1. INTRODUCTION

The Port is seeking non-material variations to the project’s Marine Construction Licence in accordance with section 30(7) of the Marine Scotland Act 2010. This document sets out the details of the requested variations and explanation of their non-material nature.

DEEP WATER TERMINAL PROJECT**REQUEST FOR NON MATERIAL VARIATION TO MARINE CONSTRUCTION LICENCE****APPENDIX 1****INDICATIVE DETAILS OF FLOATING LINKSPAN**

REQUEST FOR NON MATERIAL VARIATION TO MARINE CONSTRUCTION LICENCE

DRAWING TITLE
**LINKSPAN
ROCK BREAKOUT
GENERAL ARRANGEMENT**

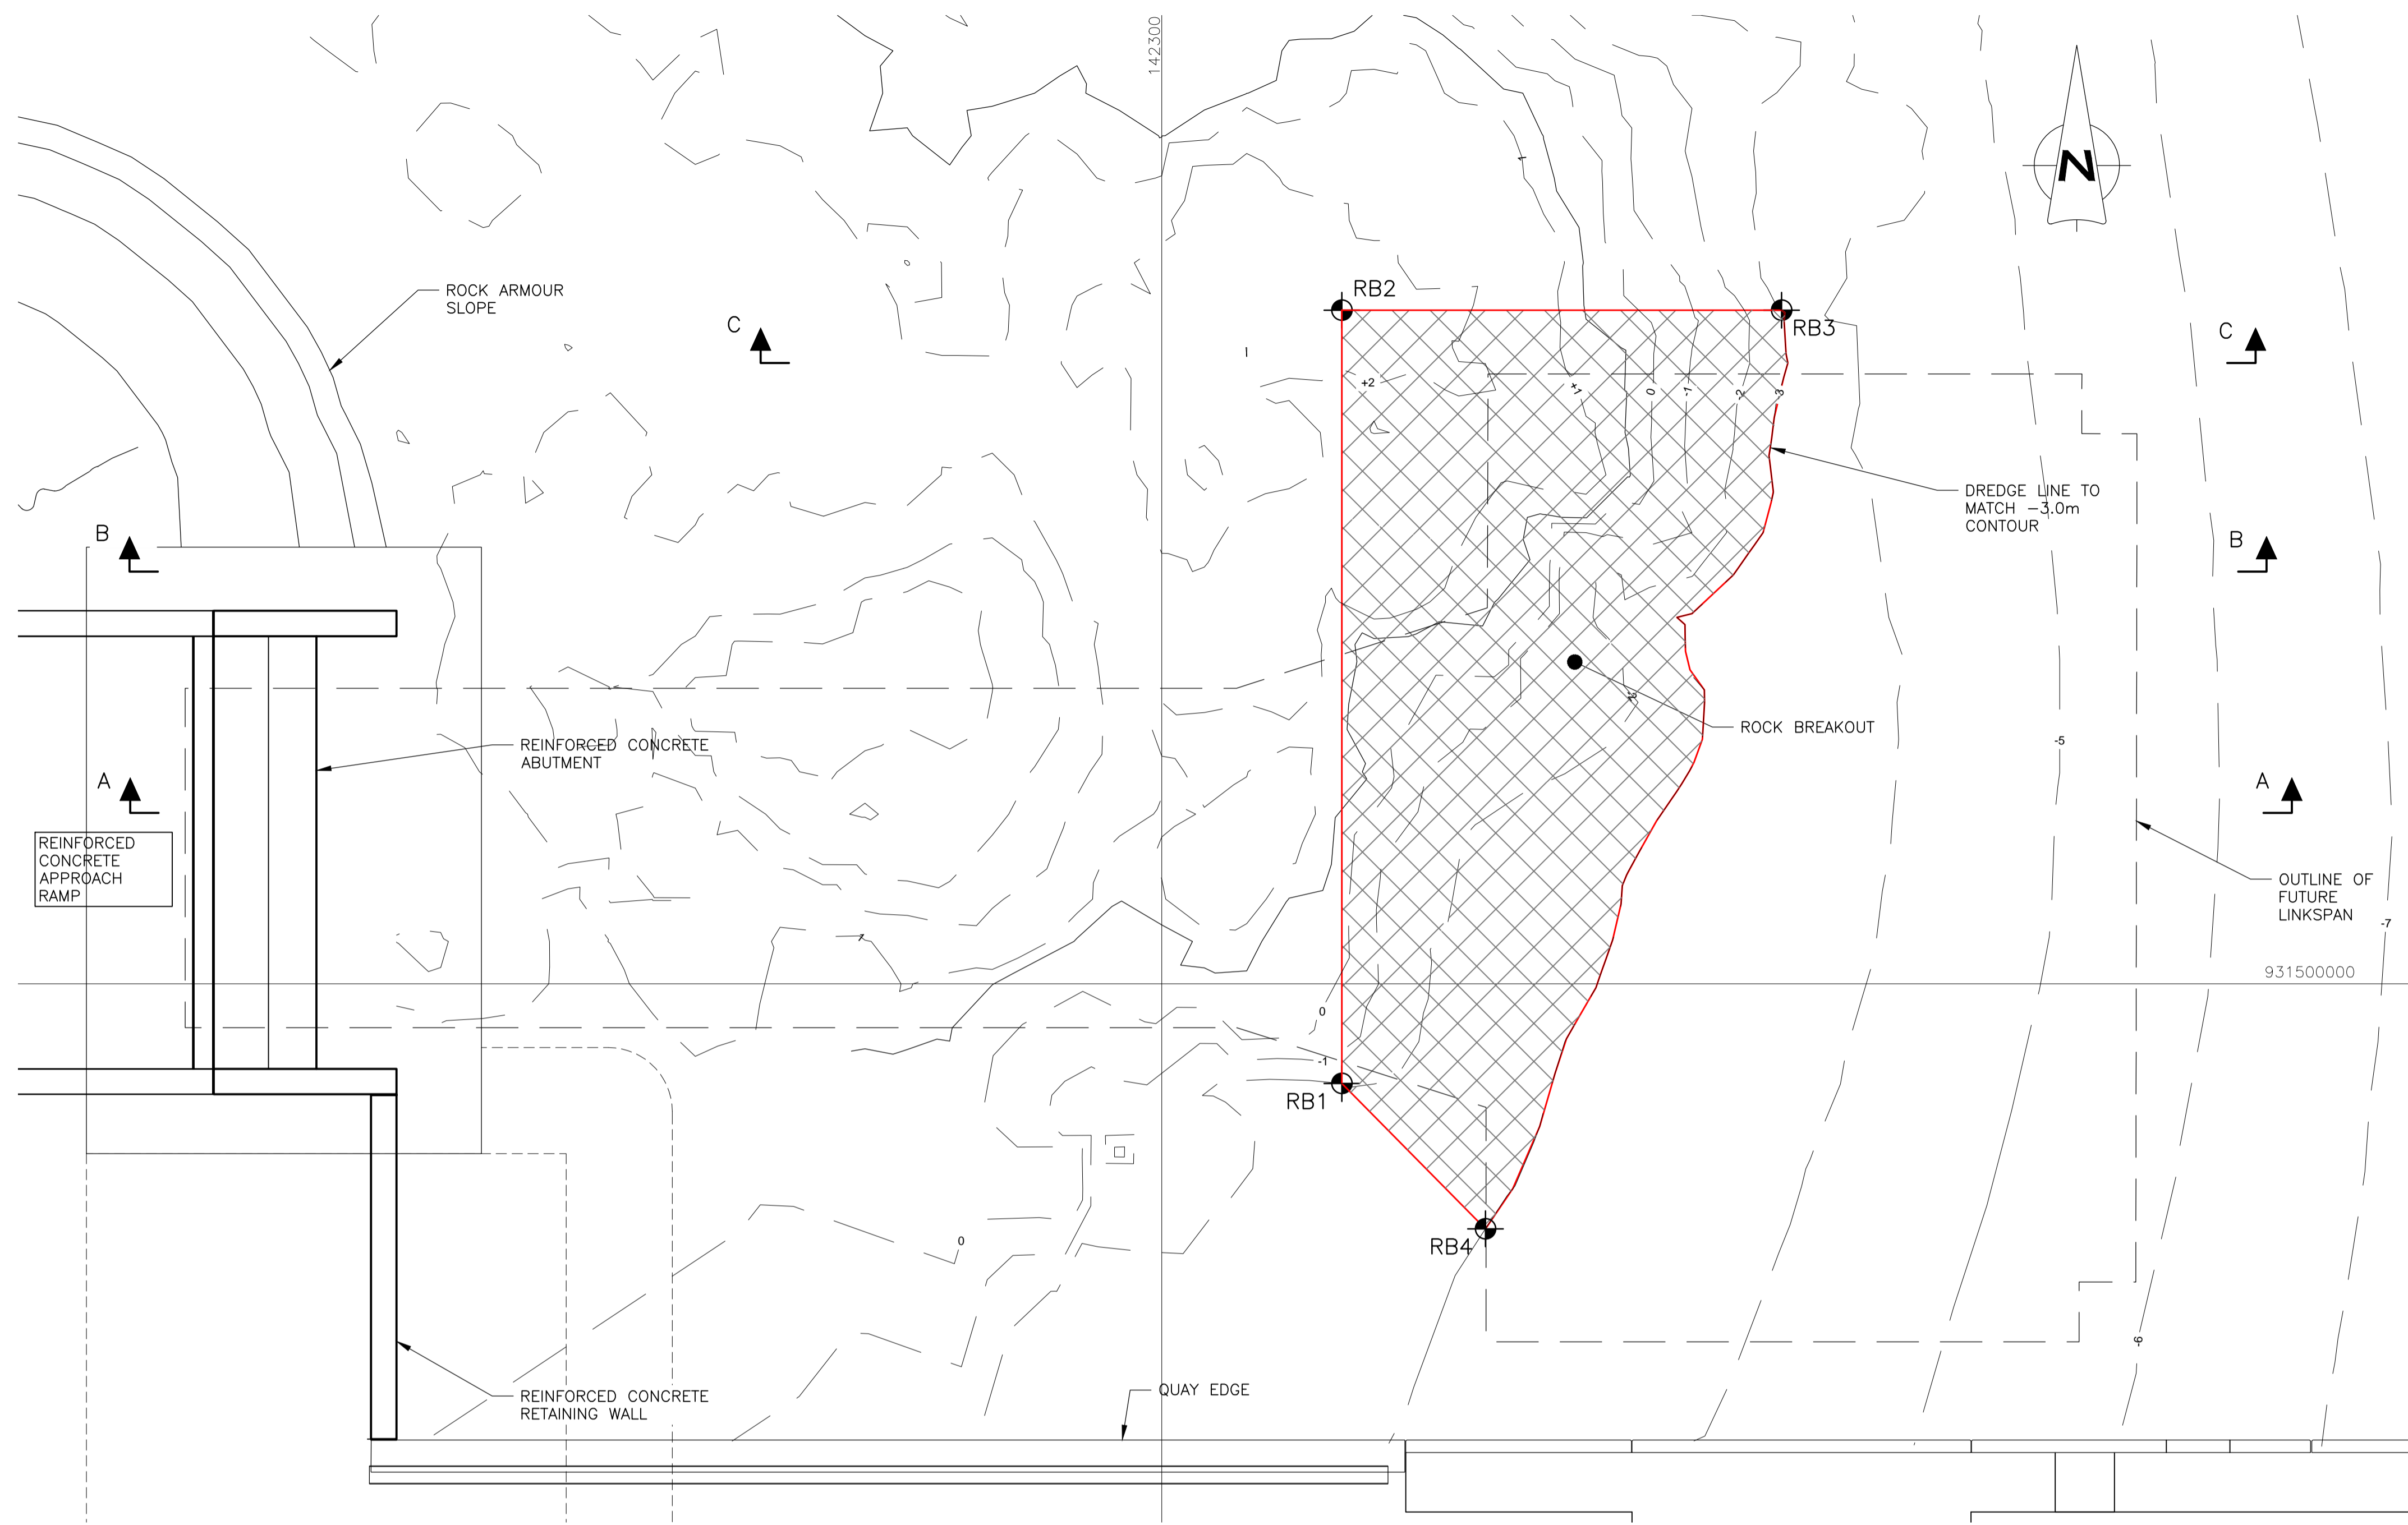
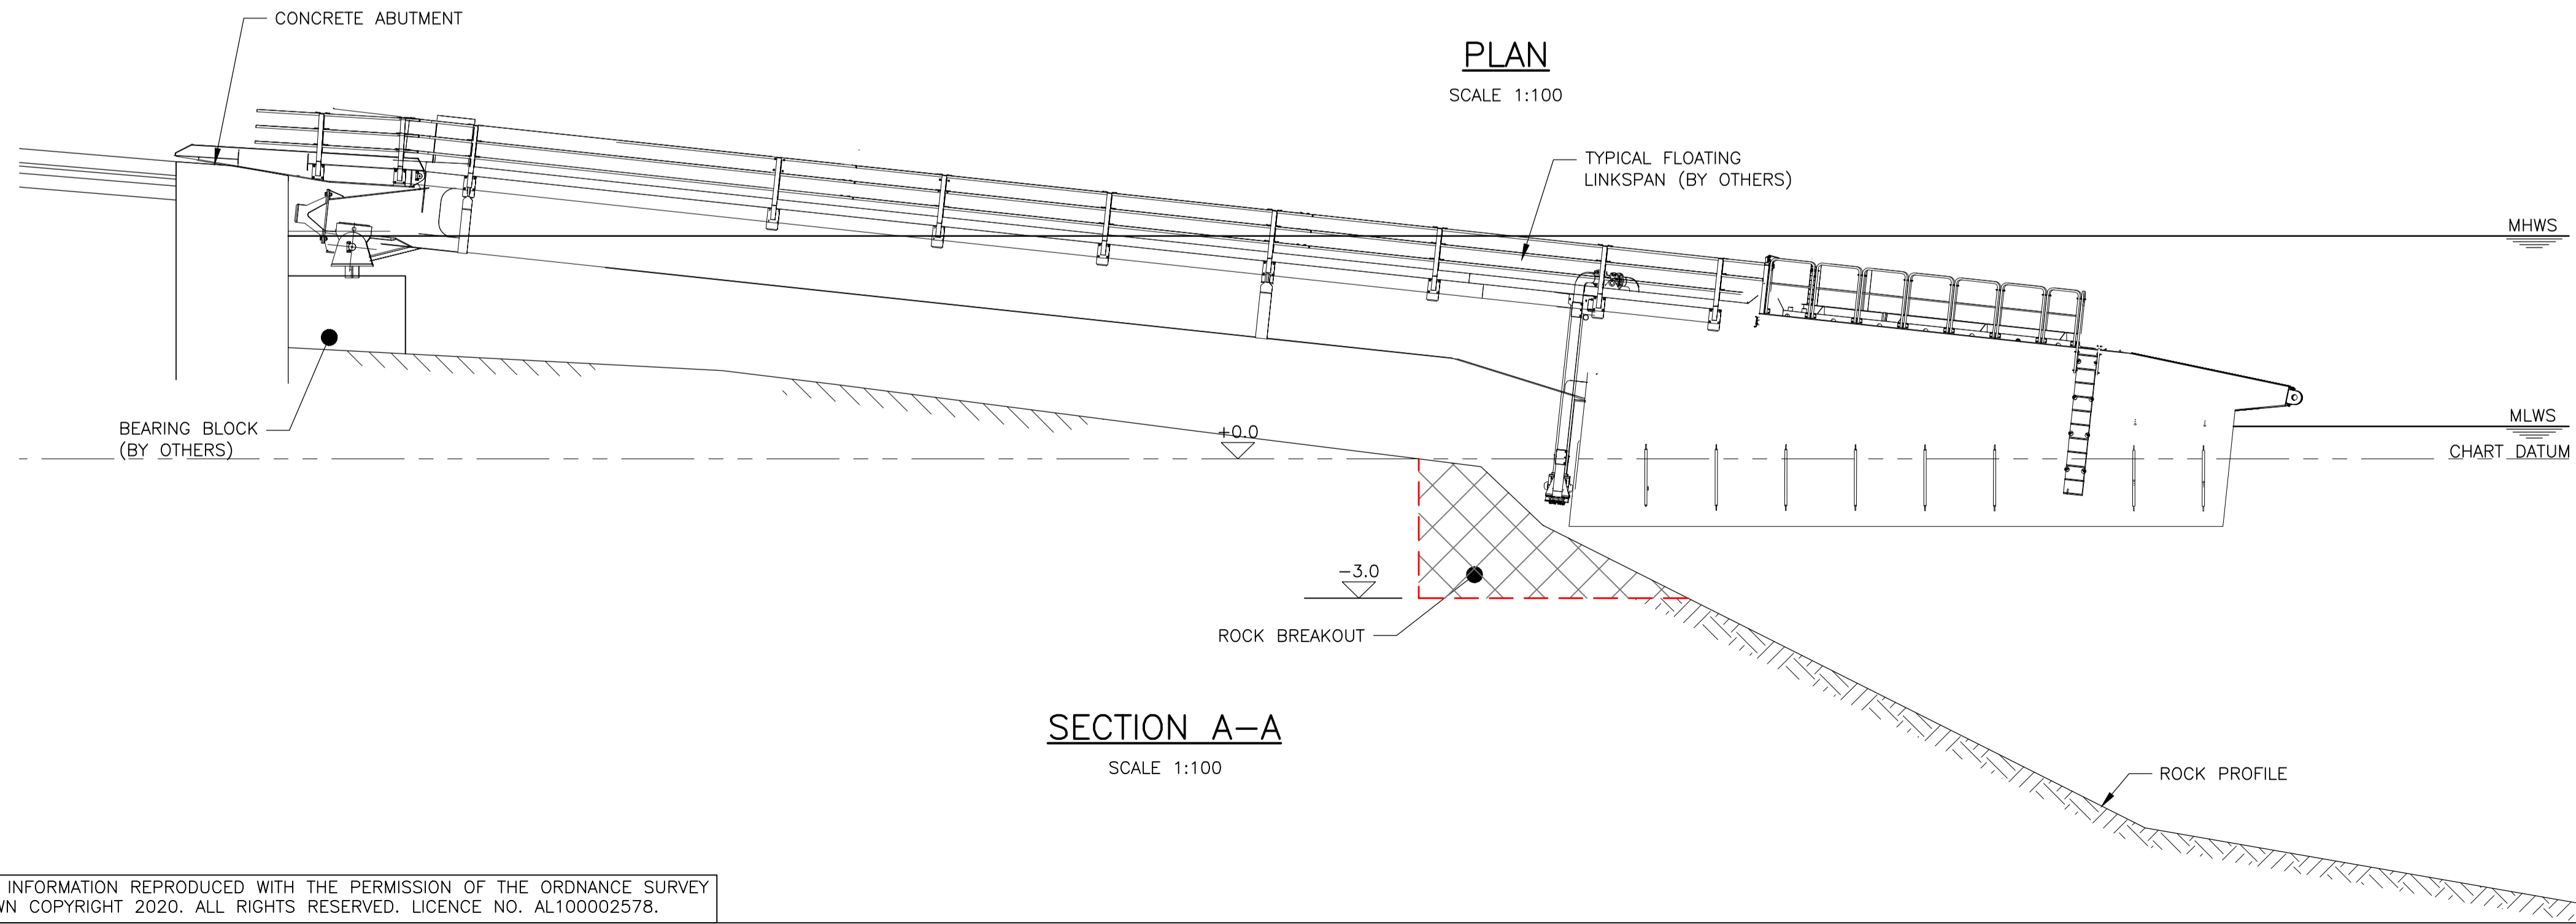
In order to accommodate the buoyancy tank, the bed level at the buoyancy tank location requires to be at least -3.00mCD. A small area of rock (approximately 157m² in area) is above this level. This rock requires to be removed to facilitate the installation of a floating linkspan.

The drawings in Appendix 3 (SDWP-WS2139-XX-00-DR-C-9087 P01 and SDWP-WS2139-XX-00-DR-C-9088 P0) provide a detailed plan and sections of the rock removal area.

The quantity of rock required to be removed has been calculated as 200m³. Allowing 25% for overbreak achieves a total quantity for removal of 250m³. However, the exact quantity of rock to be removed will be determined by the detailed design of the linkspan float. Therefore, the proposed quantity for the purpose of the application for variation of the construction licence is 300m³.

It is proposed to remove this rock by splitting it with a hydraulic breaker then removing the material with an excavator mounted on a temporary bund of crushed rock comprised of material from the Stornoway Deep Water Terminal works. The estimated duration of this work is one to two weeks.
